Work Order ID 149805

Item Name: Fwd Crosstube - High 407

DRAWING NO. D407-667-145	TITLE CROSSTUBE ASS'Y (407 HIGH FWD)	REV. C	DART AEROSPACE LTD ENGINEERING ORDER		D.E.O. NO. D407-667-145-C-1	SHEET NO. SHEET 1 OF 1	SCALE NTS
DRAWN 97	CHECKED ASS	MFG. APPR. 182	APPROVED WD		DE APPR. H		
DATE 11.07.15	DATE 11.07.22	DATE 11.07.22	DATE 11/07/22		DATE 11.07.21

DRAWING NO. D407-667-145	TITLE CROSSTUBE ASS'Y (407 HIGH FWD)	REV. C	DART AEROSPACE LTD ENGINEERING ORDER	D.E.O. NO. D407-667-145-C-2	SHEET NO. SHEET 1 OF 1	SCALE NTS
DRAWN AJS	CHECKED <i>[Signature]</i>	MFG. APPR. <i>[Signature]</i>	APPROVED <i>[Signature]</i>	DE APPR. <i>[Signature]</i>		
DATE 12.08.02	DATE 12.08.02	DATE 12.08.02	DATE 12.08.02	DATE 12.08.02	DATE 12.08.02

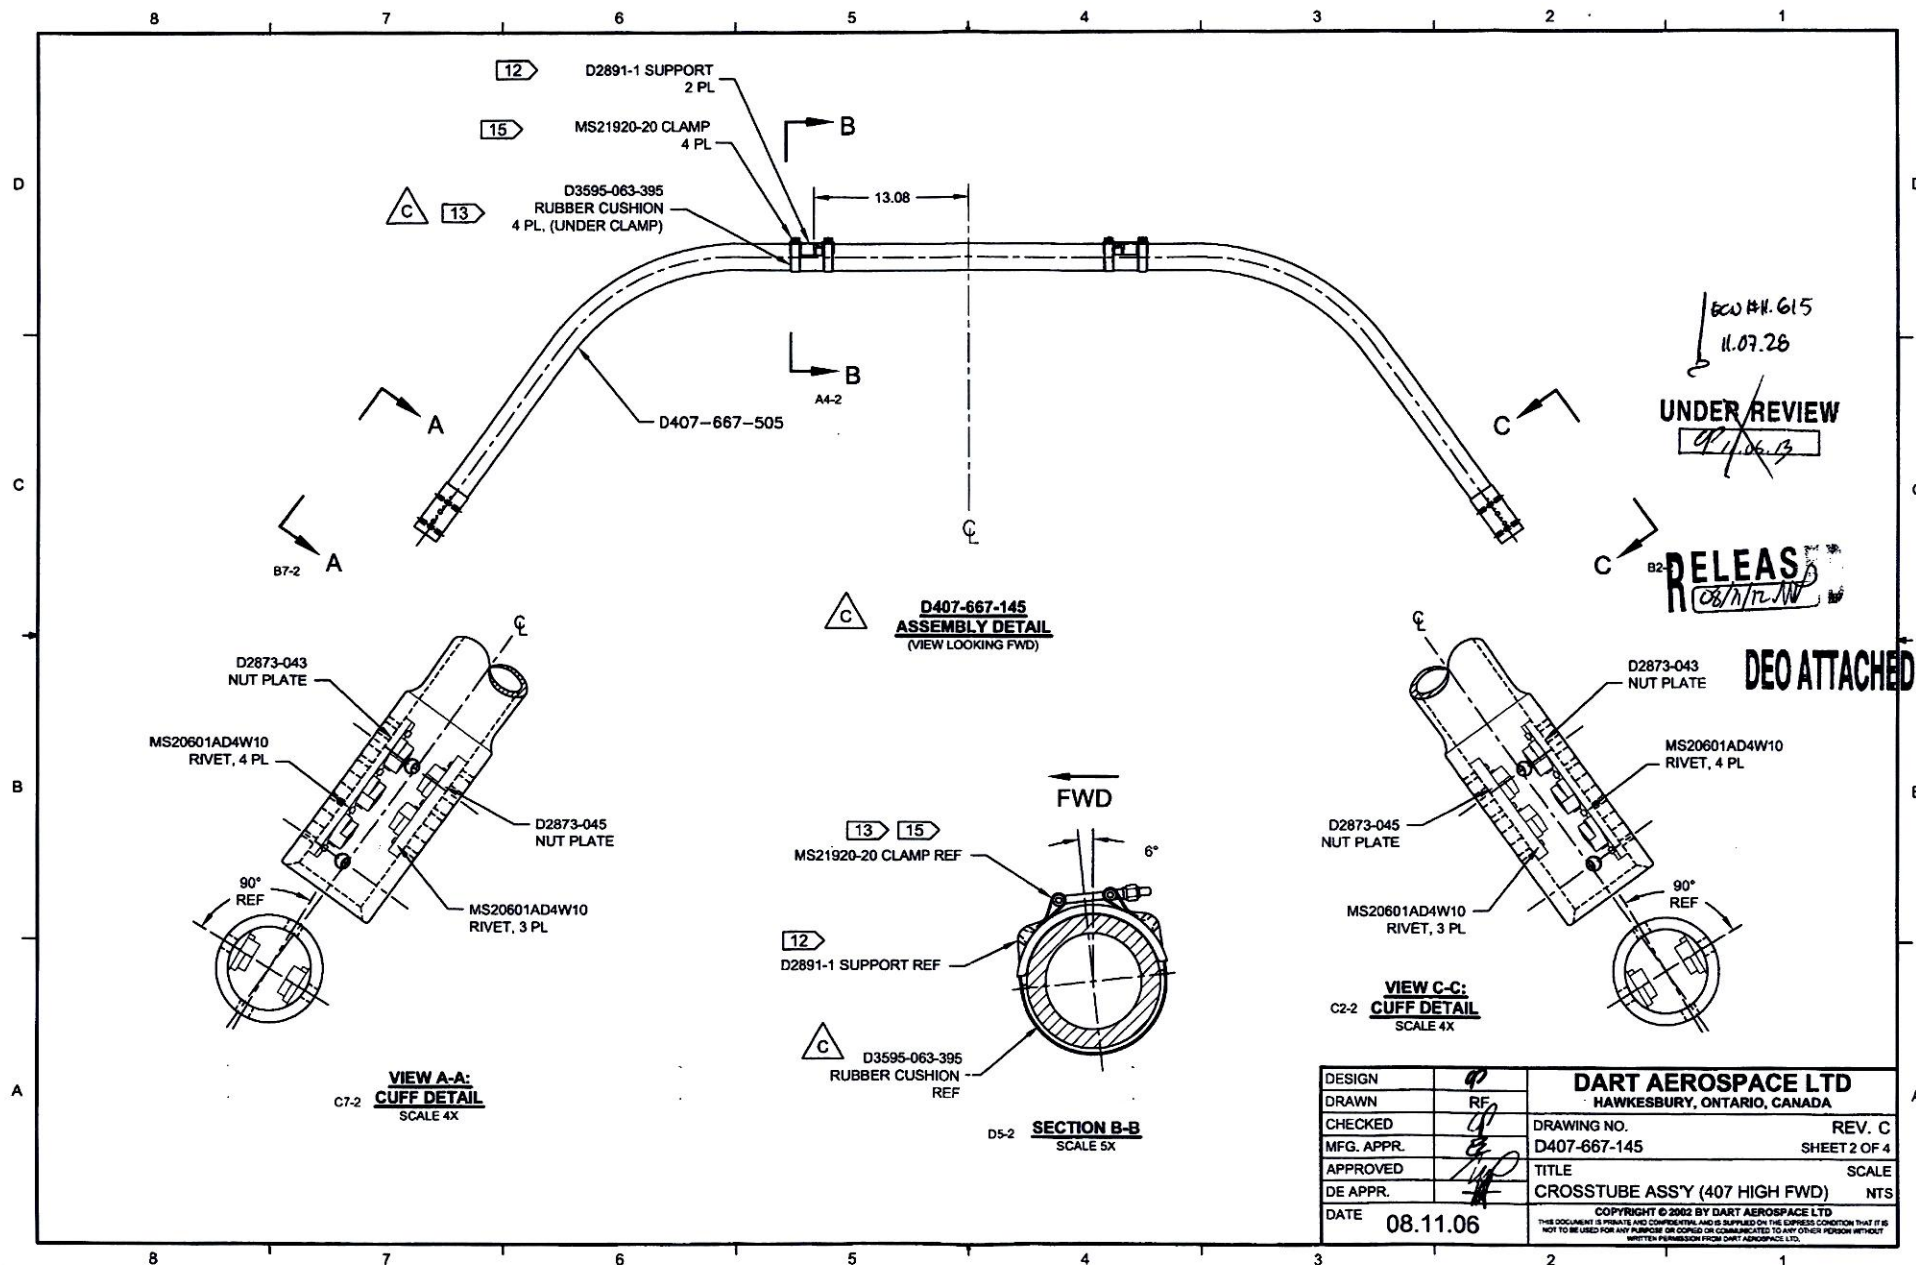
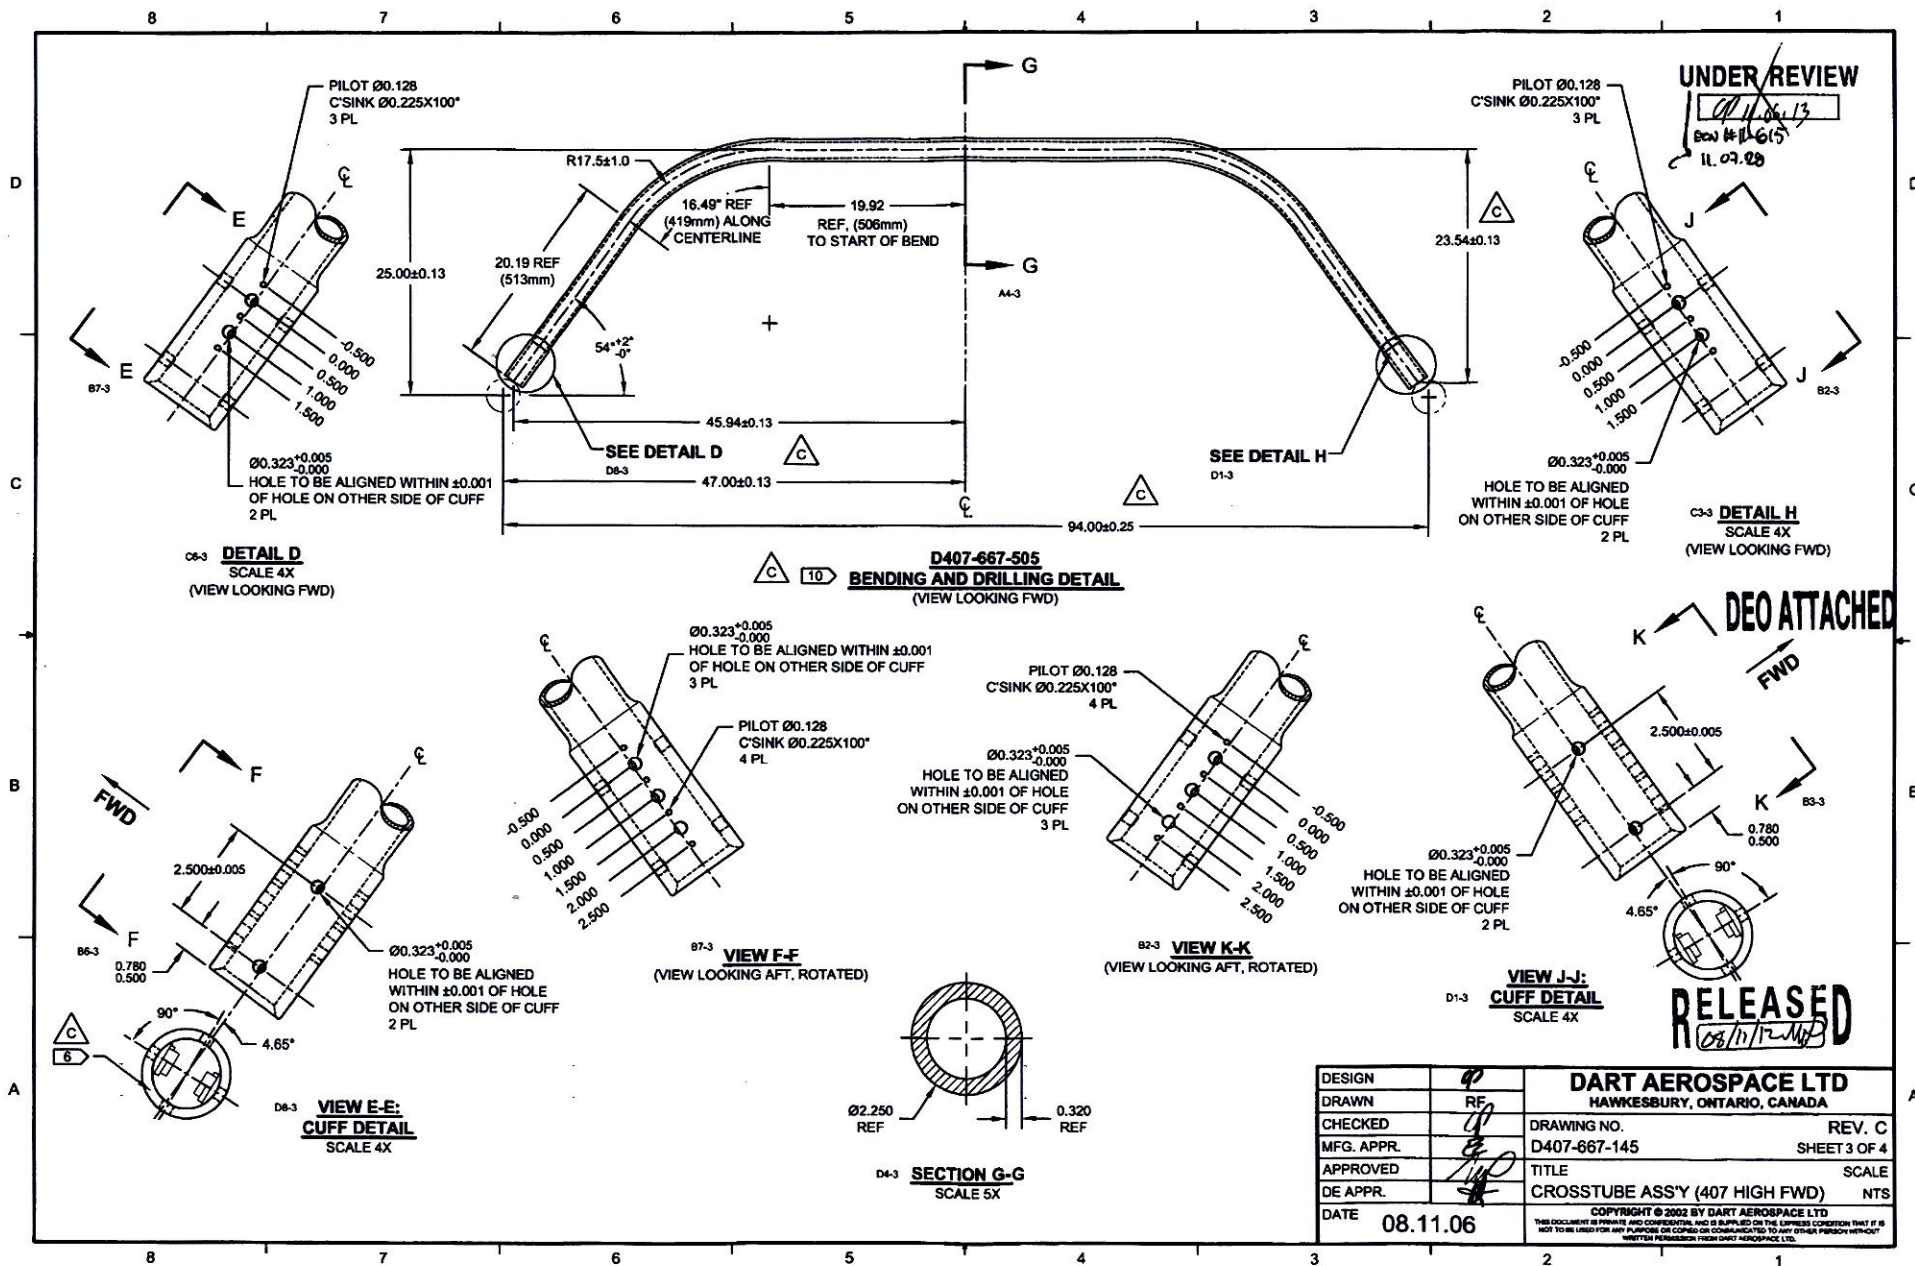
PURPOSE:

REPLACE MAGNOBOND WITH PROSEAL.

NOTE 12 & 15, SHEET 1 IS AMENDED AS FOLLOWS:

- 12) TO INSTALL D2891-1 SUPPORT: ABRASE MATING SURFACE OF SUPPORT AND CROSSTUBE WITH 180-GRIT SANDPAPER AND REMOVE RESIDUE WITH MEK (OR EQUIVALENT). APPLY A 0.04" TO 0.07" THICK LAYER OF PROSEAL 890 CLASS B-2 (OR AMS-S-8802 CLASS B-2) SEALANT TO MATING SURFACE OF SUPPORT.
- 15) TORQUE CLAMPS 80 TO 100 IN-LB. ENSURE AT LEAST 1.5 THREADS SHOWING IN SAFETY AND THAT NUT HAS NOT BOTTOMED-OUT AFTER TORQUING. **PRIOR TO PACKAGING, RE-CHECK TORQUE ON CLAMPS AFTER PROSEAL 890 SEALANT HAS CURED FOR 72 HOURS.**

DETAIL P
 BONDING STRAP INSTALLATION 2 PL

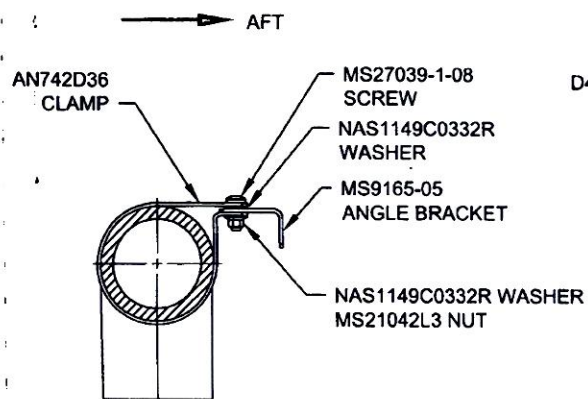
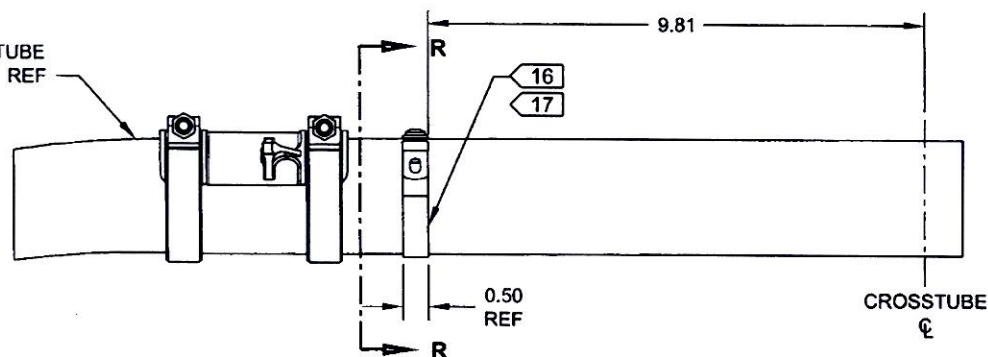
PURPOSE:

ADD ELECTRICAL GROUNDING STRAP

- 16) MASK AREA UNDER CLAMP PRIOR TO PAINTING
- 17) SEAL EDGES WHERE AN742D36 CLAMP MEETS WITH THE CROSSTUBE USING SIKAFLEX-241/-291 OR MIL-S-8802 CLASS B2 OR PROSEAL 890 SEALANT
- 18) PERFORM RESISTANCE CHECK TO ENSURE MAX RESISTANCE IS 10 MILLIOHMS
